ADA Curb Ramp New Construction Inspection Form (Combination)

NW Curtis

NW Pacific

COMBINATION RAMP (C)

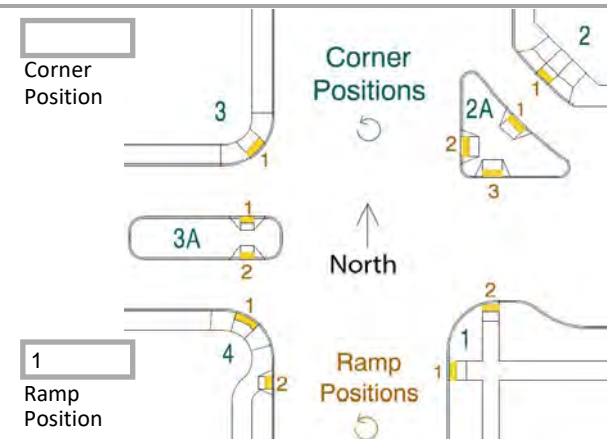
☒

☒

☒

☒

☒

Ramp run 3-crack in walking path
